Static geometric measurements on head restraints

This document is a further explanation of the comments from the Netherlands on measuring techniques during the GTR head restraints meeting February 2005

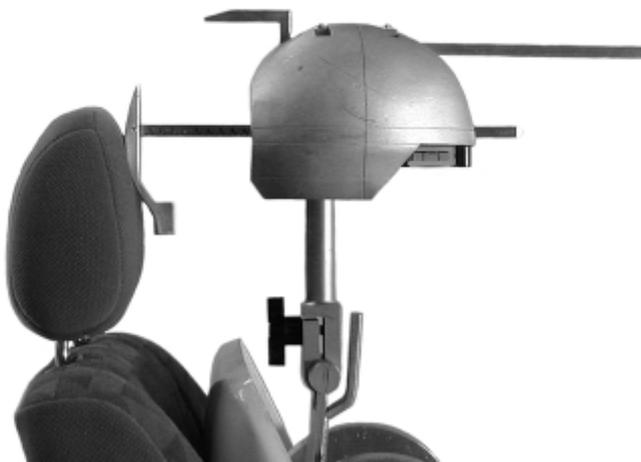
- Although the latter regulation makes use of a different measuring tool, we conclude that both regulations only focus on the uttermost height of the head restraint;

- We judge it important that the measurement procedure for the height of a head restraint leads to the determination of a maximum height being that part of the head restraint which is relevant for, **close enough to!**, the head that has to be protected;

- Therefore a measurement procedure for maximum height of head restraints should be **related to backset**. In other words the height that will be determined as the maximum height of the head restraint should have a backset which is not bigger than .. mm when compared with the backset determined by the probe imitating the rear of the human head;

- Furthermore, this concept should also count for a part of the front surface of the head restraint hereafter called *Catching Zone*;
- The dimensions of the *Catching Zone* can be derived from existing requirements concerning the minimum width and height of head restraints.
